UNITED STATES PATENT AND TRADEMARK OFFICE

APPLICATION NO.	FILING DATE	FIRST NAMED INVENTOR	ATTORNEY DOCKET NO.	CONFIRMATION NO.
10/828,423	04/19/2004	Kyeong Hwan Doo	5895P057	5360
8791 7590 04/11/2007 BLAKELY SOKOLOFF TAYLOR & ZAFMAN 12400 WILSHIRE BOULEVARD SEVENTH FLOOR LOS ANGELES, CA 90025-1030			EXAMINER ROJAS, OMAR R	
			ART UNIT 2874	PAPER NUMBER
SHORTENED STATUTORY PERIOD OF RESPONSE		MAIL DATE	DELIVERY MODE	
3 MONTHS		04/11/2007	PAPER

Office Action Summary

DETAILED ACTION

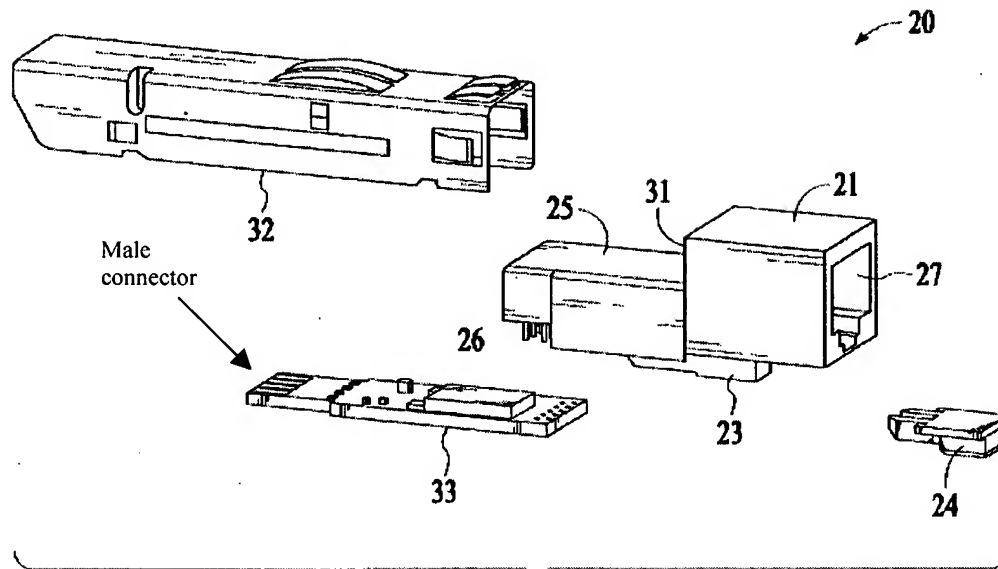
In re claims 1-3, Engel discloses, in Figures 1-6, an optical module interfacing device 20, connected to a female connector 12 for an SFP type module for providing data transmission/reception functions through an UTP cable, comprising:

a board 33 having the same dimensions as those of the optical module;

a male connector (see the modified Figure 3 of Engle below), having the same dimensions as those of the optical module, formed at a side surface of one end of the board 33 and connected to the female connector 12 for the optical module mounted on a host board 11; and

an RJ-45 female connector 21' provided with a plurality of pins 26 formed on an upper surface of the board, respectively corresponding to pins of the male connector, according to standards;

wherein the board 33 and the male connector have the same dimensions as the SFP type optical module (column 2, lines 32-35). For applicant's convenience, a modified version of Figure 3 of Engel is reproduced below that includes a label for the male connector.

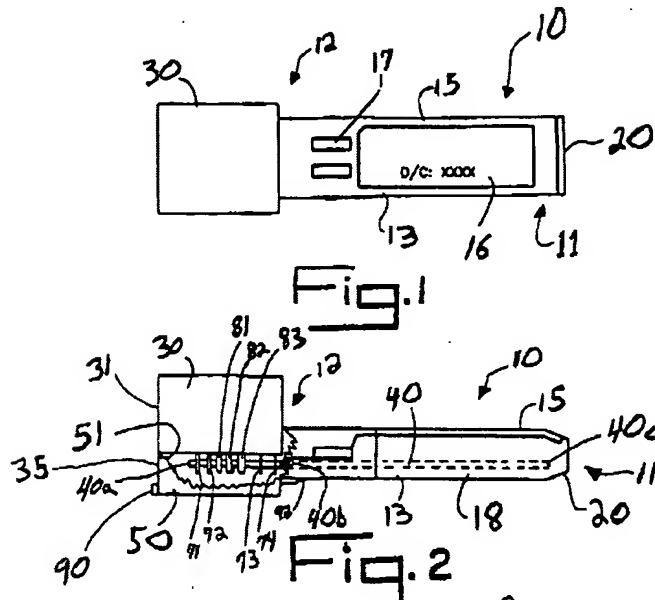
In re claims 1-3, Daly discloses, in Figures 1-5, an optical module interfacing device 10, connected to a host device for an SFP type module for providing data transmission/reception functions through an UTP cable, comprising:

- a board 40 having the same dimensions as those of the optical module;
- a male connector 20, having the same dimensions as those of the optical module, formed at a side surface of one end of the board 40 and connected to the host device; and
- an RJ-45 female connector 30 provided with a plurality of pins 71-74 formed on an upper surface of the board, respectively corresponding to pins of the male connector 20, according to standards;

wherein the board 40 and the male connector have the same dimensions as the SFP type optical module (col. 3, line 64 to col. 4, line 2). Figures 1 and 2 of Daly are reproduced below.

FIG. 1

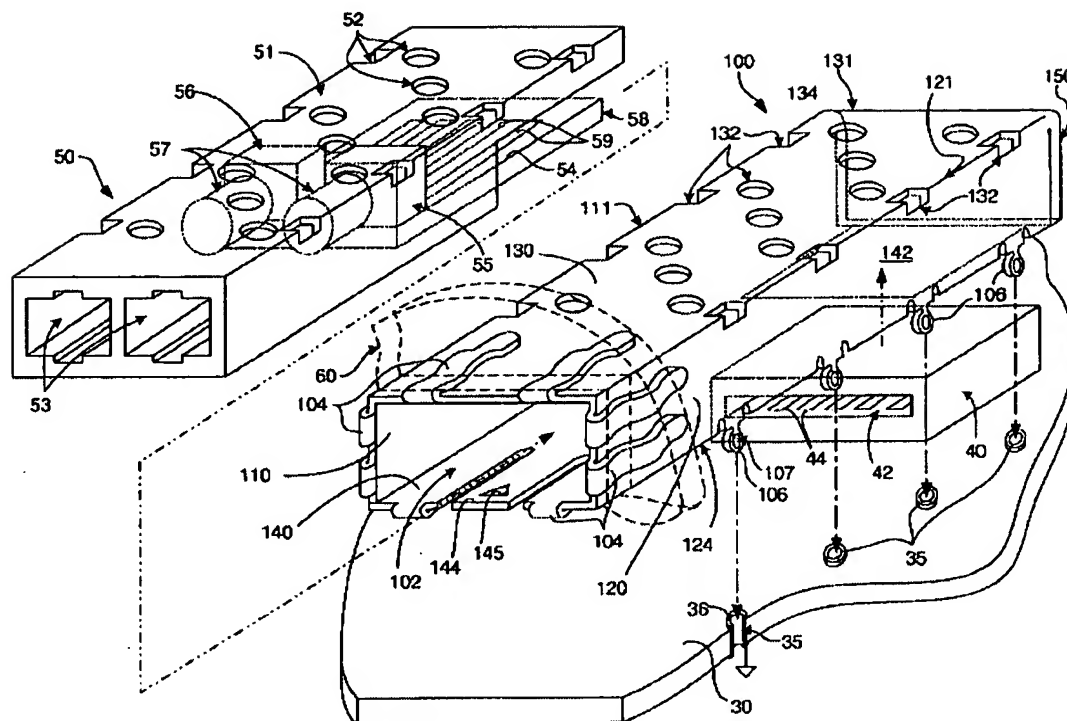
In re claims 5-7, Ahrens discloses an ethernet system (Figure 1) for supporting data communication through optical cables comprising:

a host board 30;

a physical layer (col. 4, lines 28-42), mounted on the host board, for supporting data communication through the optical cables;

an optical module 50/100 provided at an end of the optical cable, for converting an optical signal to an electric signal or an electric signal to an optical signal; and

an interfacing unit 40/42/44, mounted on the host board 30 and including a female connector 40 having the same dimensions as those of the optical module, for connecting the optical module 50/100 to optical data communication supporting ports of the physical layer when the optical module is inserted into the female connector

wherein the optical module 50/100 is detachably mounted on the interfacing unit 40/42/44. Figure 1 of Ahrens is reproduced below.

Thus, Ahrens only differs from claims 5-7 in that Ahrens does not teach an optical module interfacing means provided at an end of a UTP cable having the limitations specified by claims 5-7.
